Subject: Response to Portion of NRC Request for Additional Information Letter No. 215, Related to ESBWR Design Certification Application - Auxiliary Systems - RAI Number 9.4-53

**Response to Portion of NRC Request for
Additional Information Letter No. 215
Related to ESBWR Design Certification Application
Auxiliary Systems
RAI Number 9.4-53**

NRC RAI 9.4-53

Figure 2.16.2-2. CONAVS Functional Arrangement Diagram

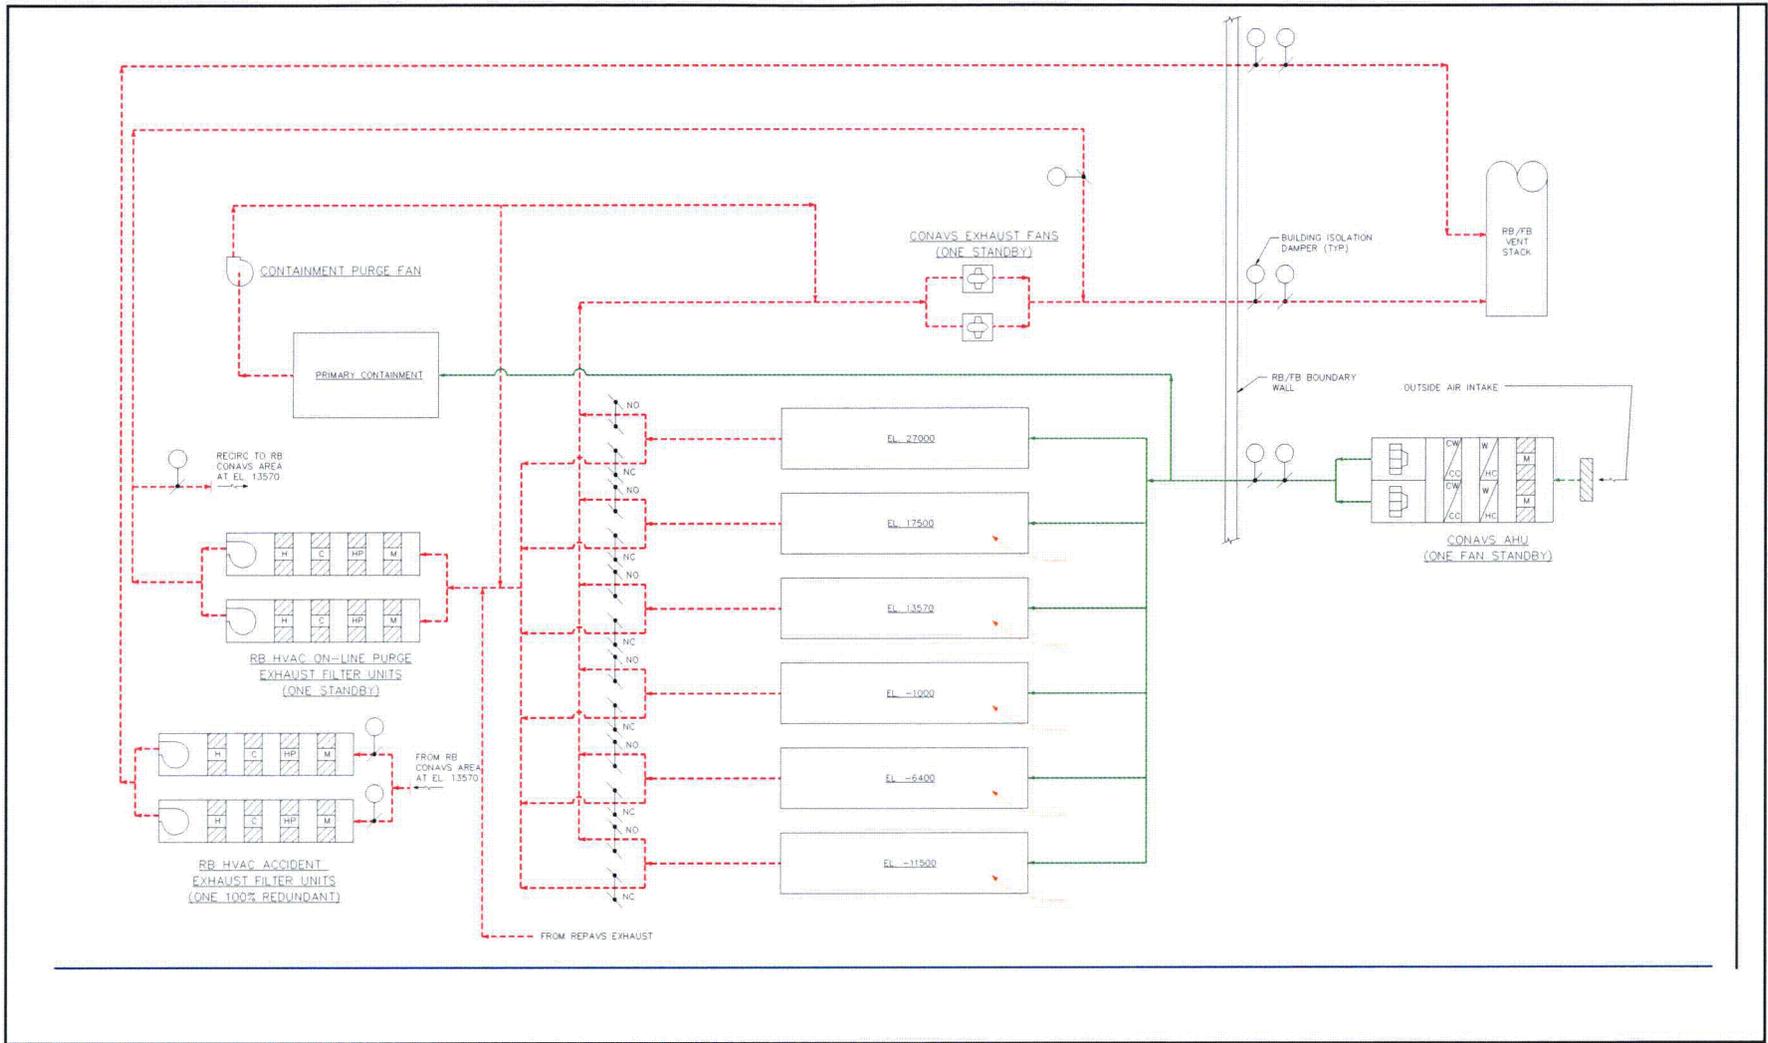
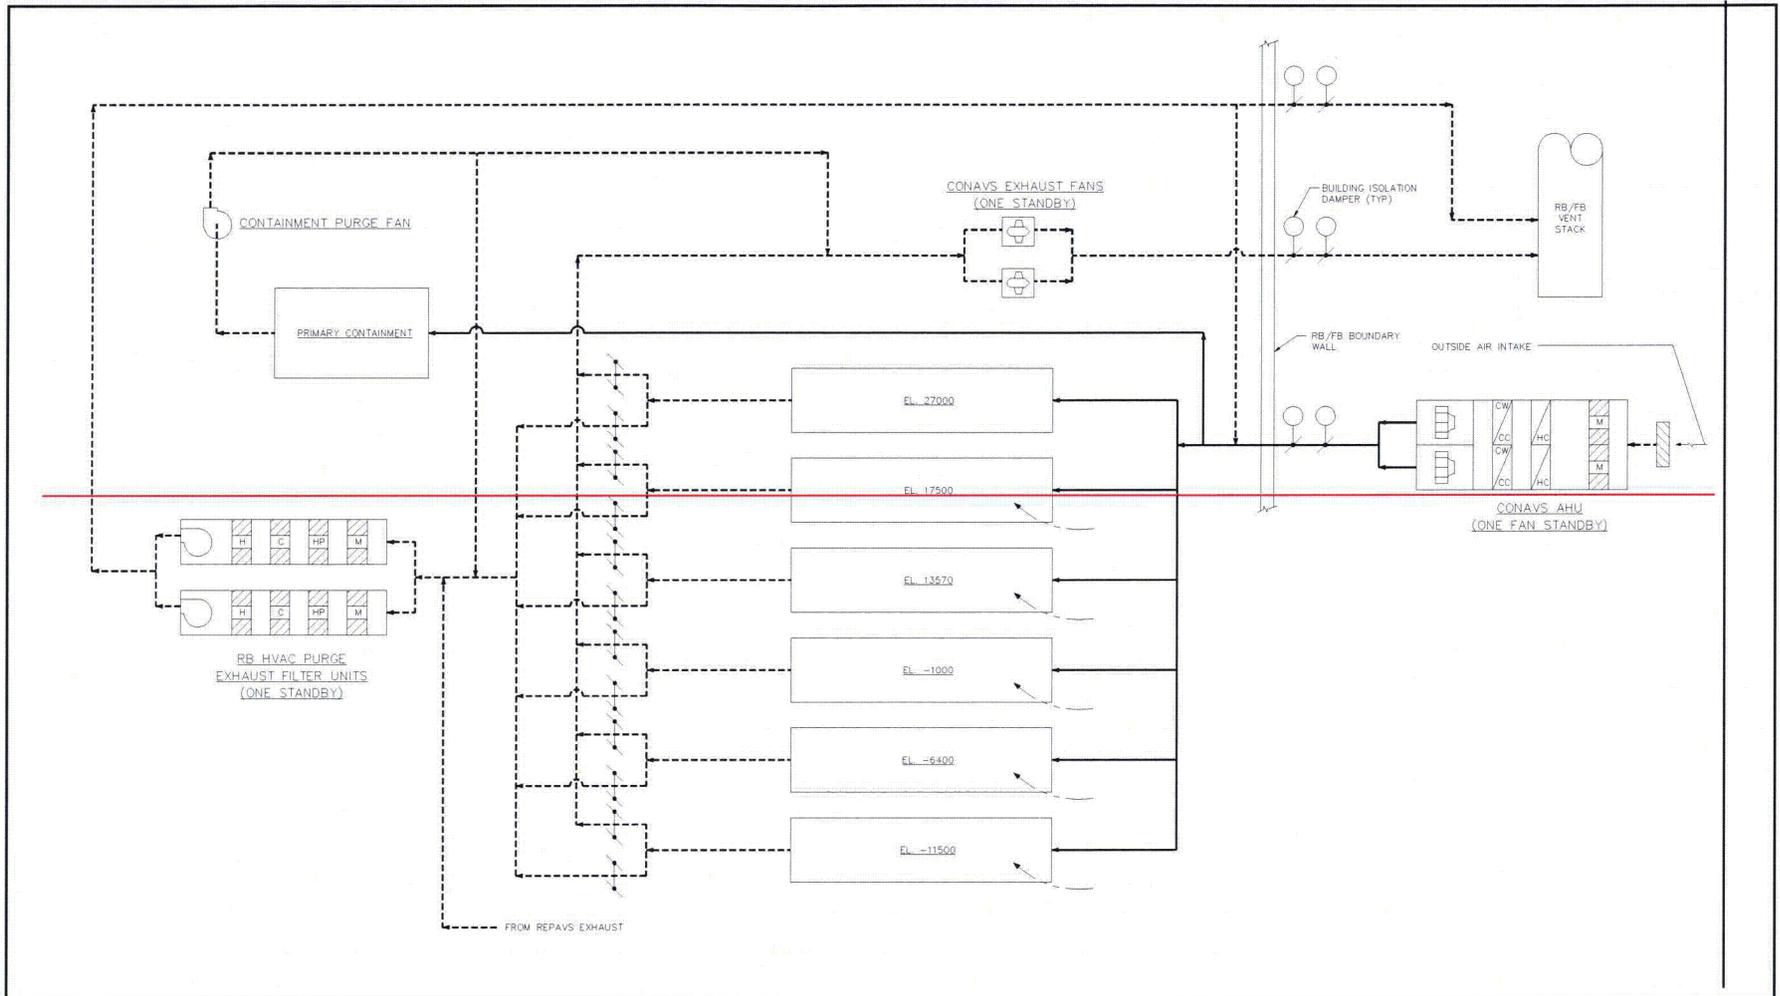
DCD Tier 1, subsection 2.16.2.1, Table 2.16.2-2, and Figure 2.16.2-2 are being updated under Revision 6 to include the write-up, tests, and figure addressing the addition of the Reactor Building HVAC Accident Exhaust Filter Units.

Figure 9.4-10. CONAVS Simplified System Diagram

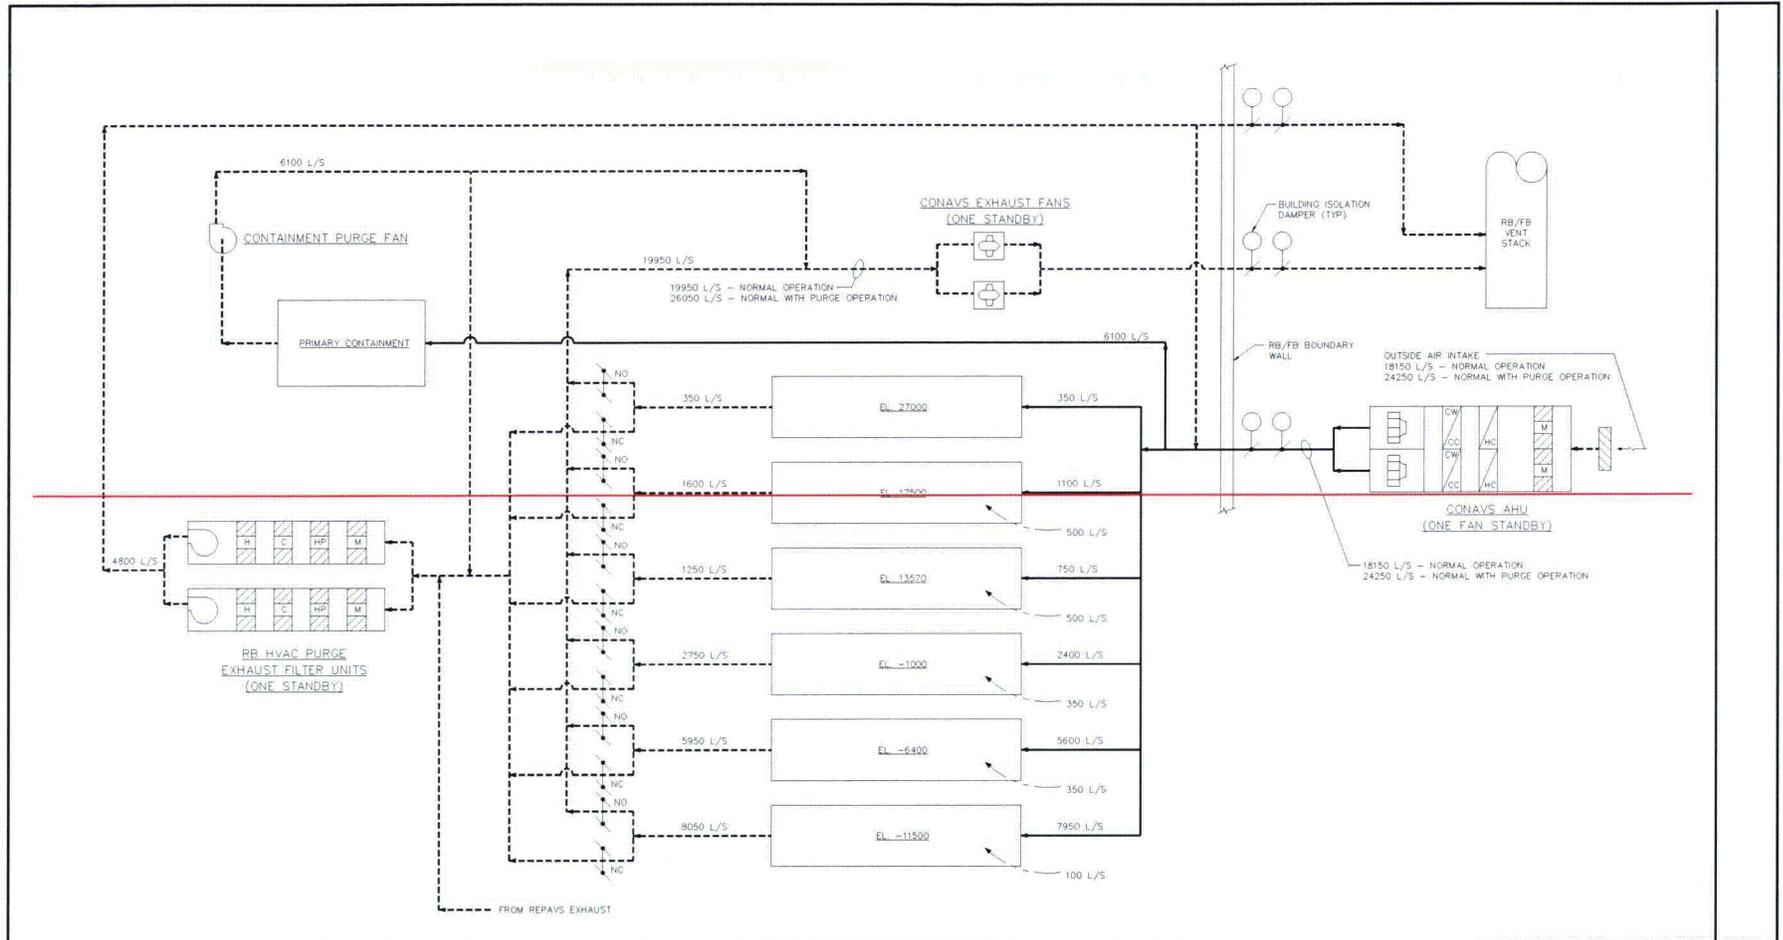
DCD Figure 9.4-10 is being updated under Revision 6 to include the Reactor Building HVAC "Accident" and "Online Purge" Exhaust Filter Unit information.
